TCEP No.: 097-035-14  
LPS No.: #7636-G

## ADDENDUM NO. 1

**Lincoln Public Schools  
 Security and Technology  
 Ready Facilities Projects  
 Project G**

Lincoln High  
 Second Floor  
 Orientation Plan &  
 Enlarged Floor Plan

**301.A01**

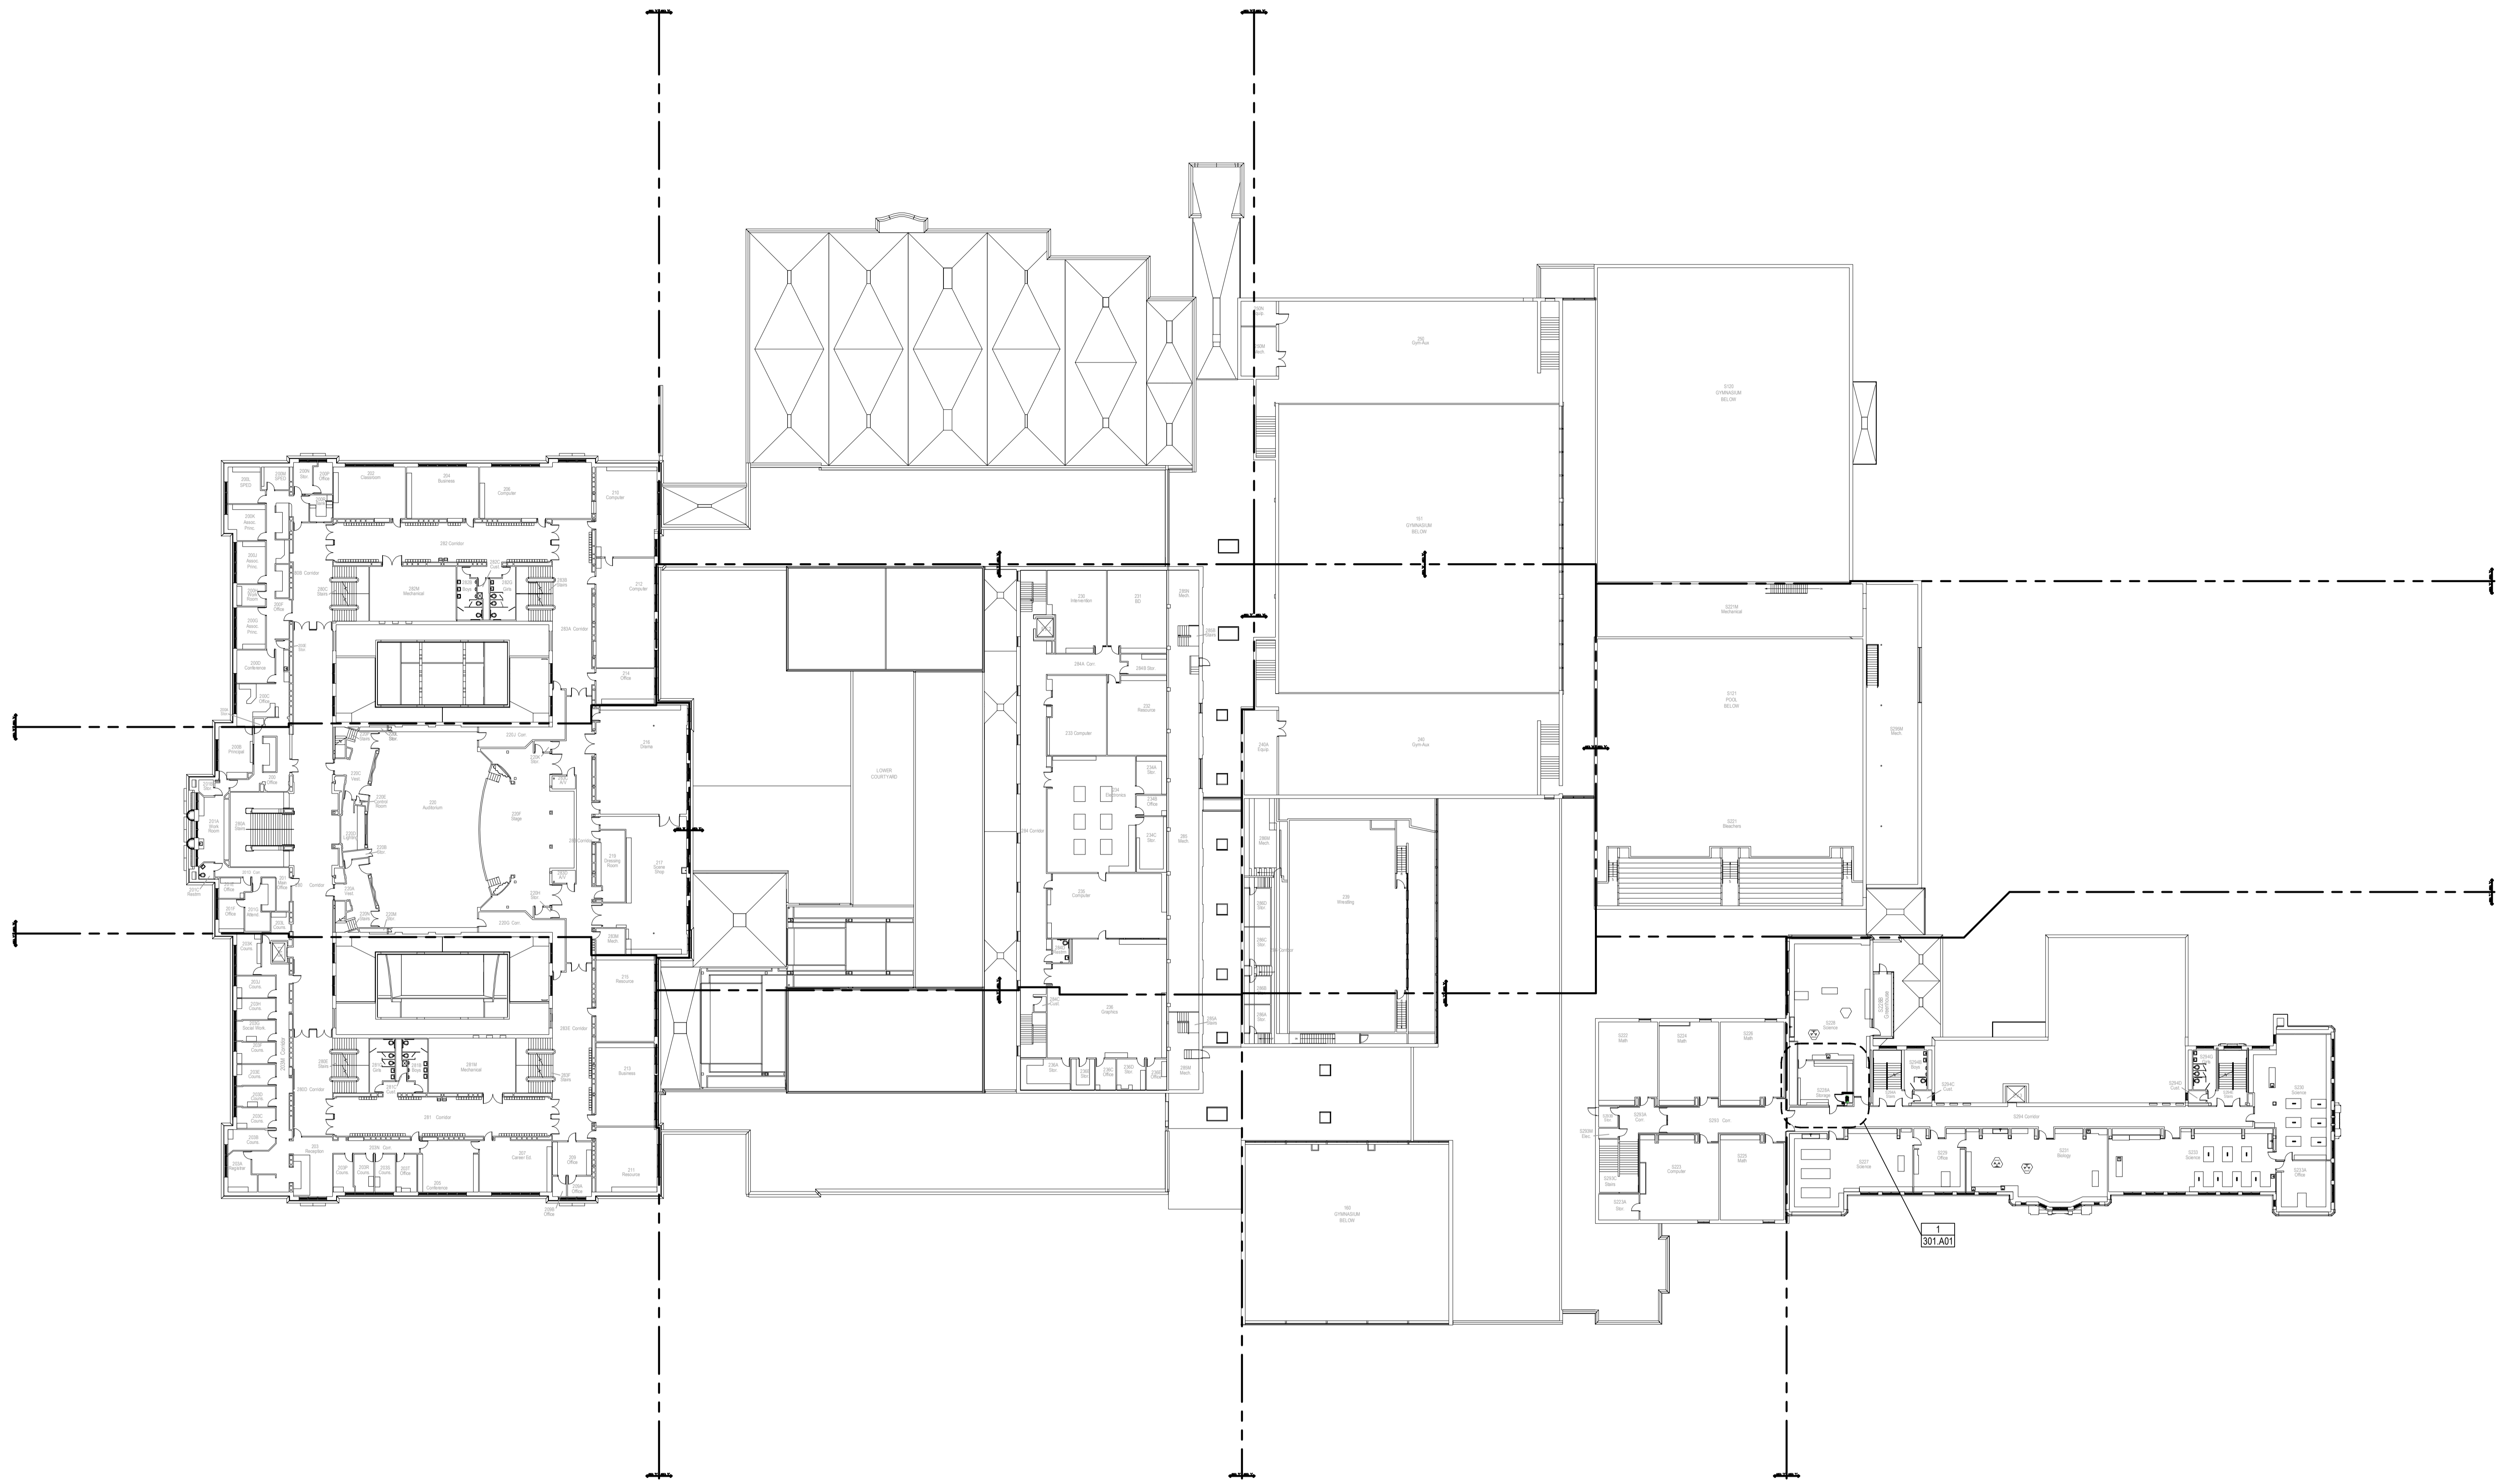
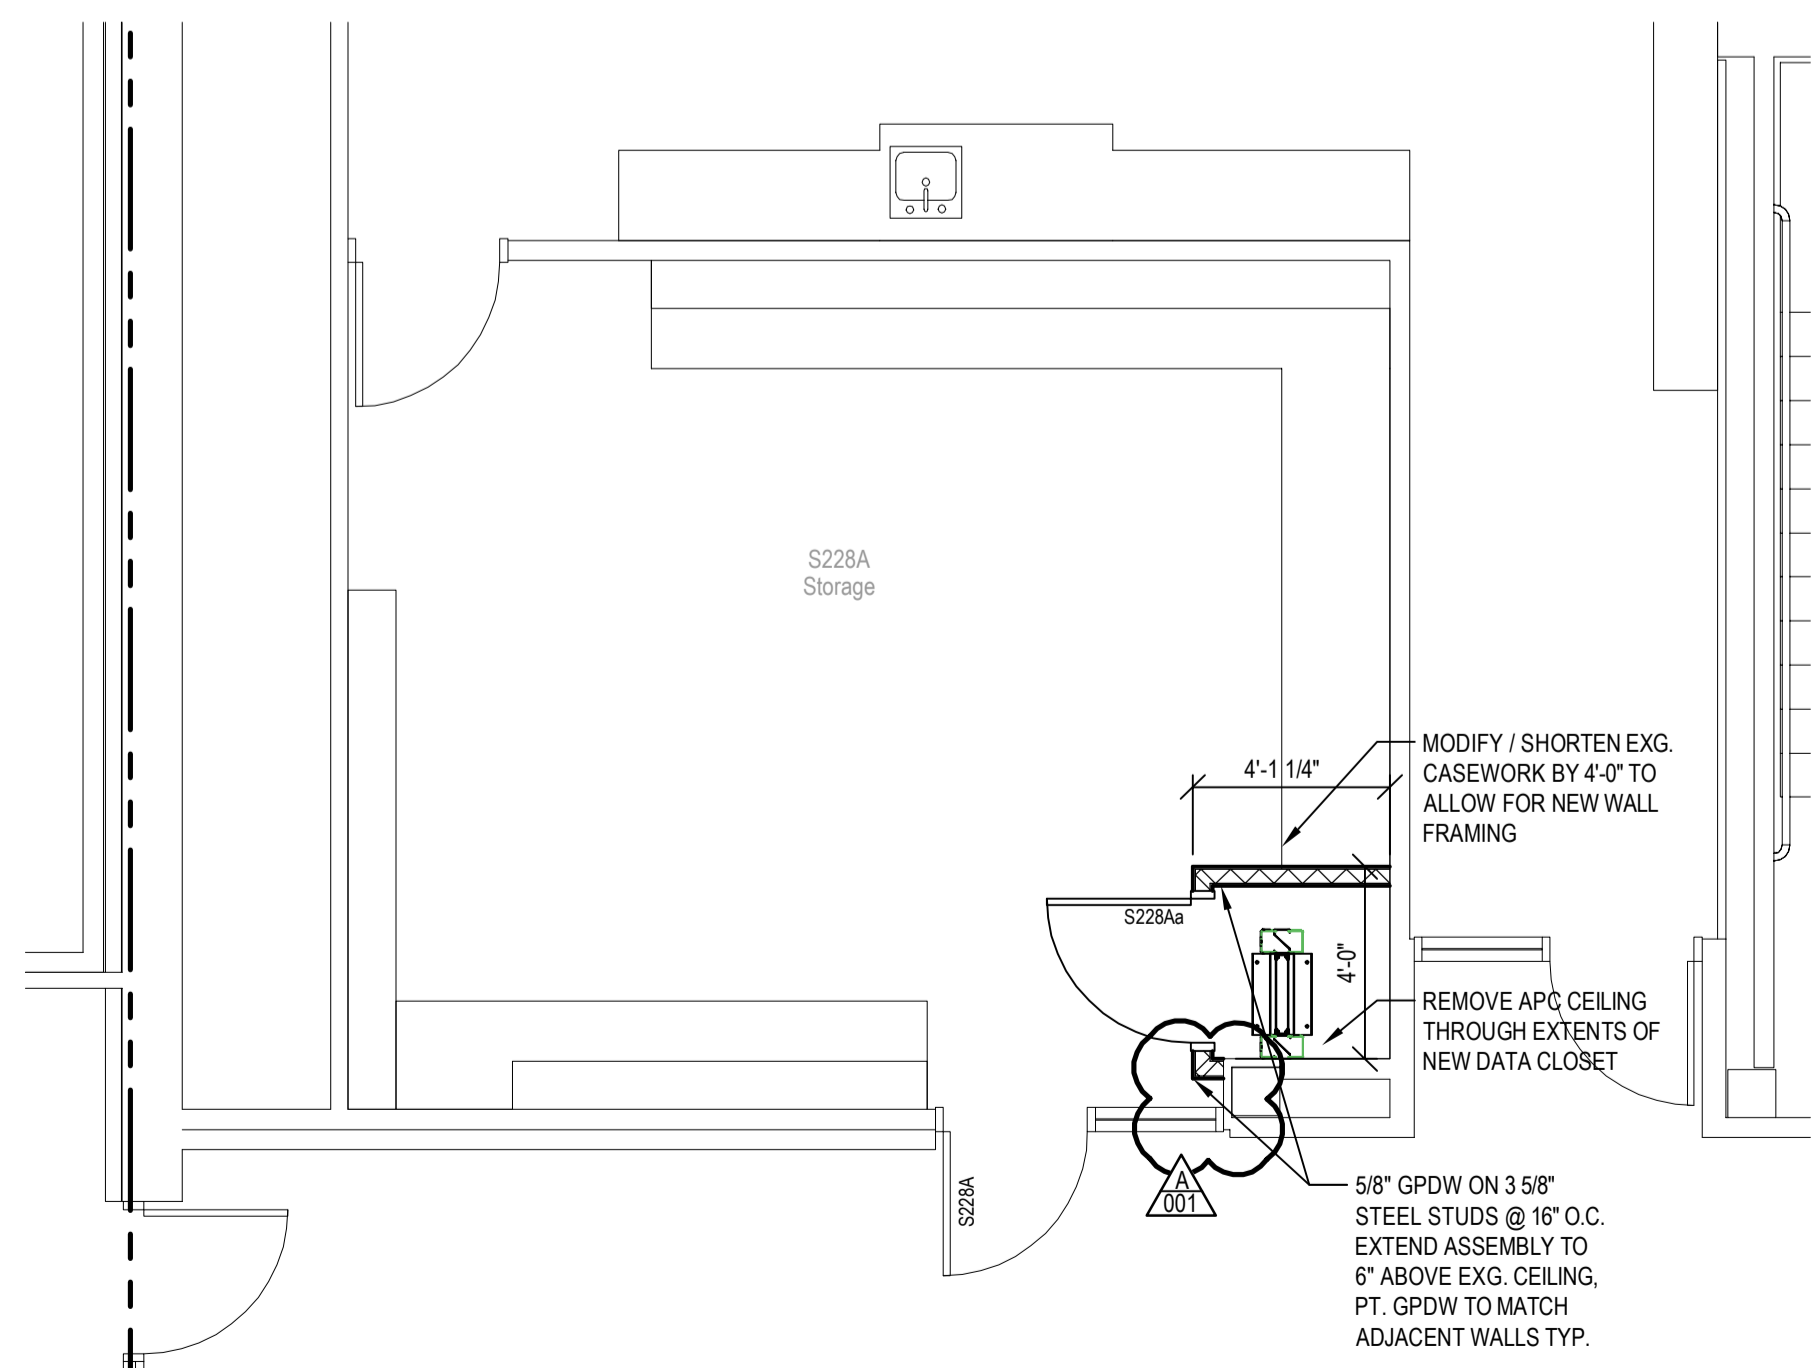
- Item 1-2: Sheet 301.A01 – Lincoln High Second Floor Orientation Plan & Enlarged Floor Plan**
- 301.A01 had been re-issued in its entirety
  - Wall layout at new data closet modified to accommodate existing door sidelight
  - Door and frame type information added
